From: Bacuta, George
Sent: Friday, June 18, 2010 2:49 PM
To: Eccleston, Charles
Cc: McCoppin, Michael; Rosenberg, Stacey; Jolicoeur, John; Bacuta, George; Imboden, Andy
Subject: RE: Section S/HC Air impacts Chapter 2 & 4.1
Attachments: 18June2010_Charle's Draft_Chapter 2 V 2 (Tech Edited version) (2).doc

Here is Chapter 2 and Section 4.1 of the Salem/Hope Creek SEIS. Please review the air impacts and make any changes in redline/strike out mode. Can you return this by next Monday 6/21?

2.0 AFFECTED ENVIRONMENT

Figure 2-5. Location of the Salem Nuclear Generating Station and Hope Creek Generating Station Site, within a 50-Mile Radius (Source: PSEG, 2009a; PSEG, 2009b)

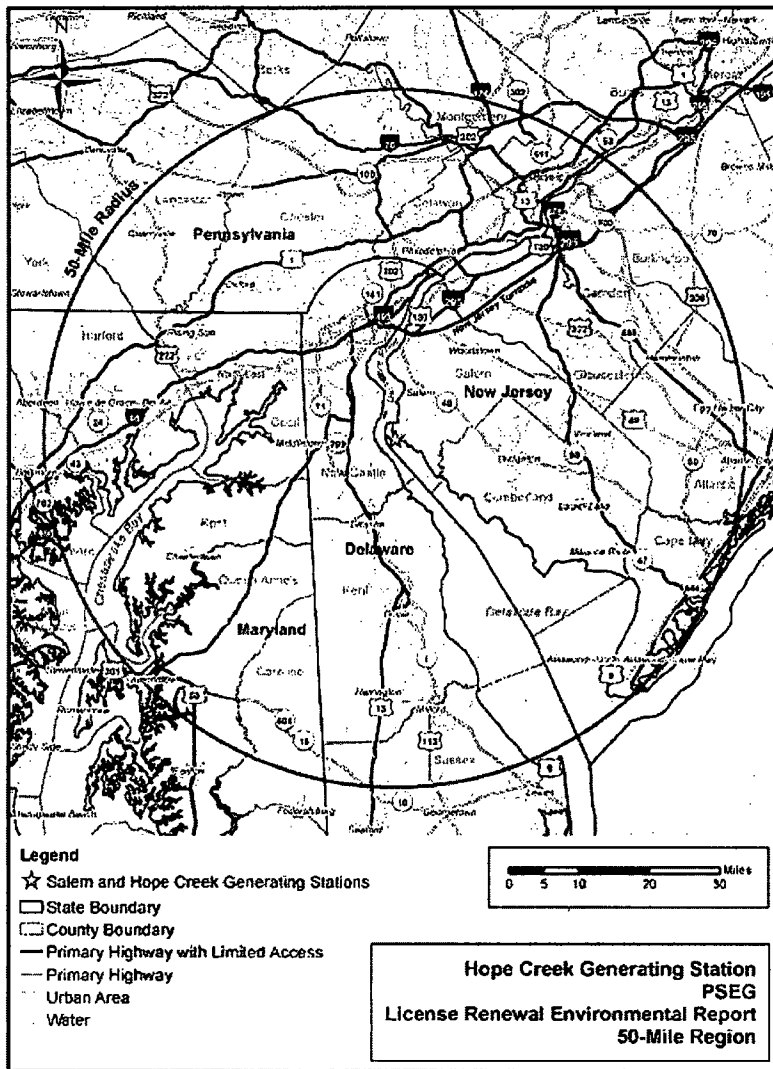
Comment [GC811]: Please check your geographic locations of Philadelphia, Delaware and Baltimore with the north direction on the map, and make necessary changes. According to Figure 2.5, Baltimore is southwest of the Salem/HC facility.
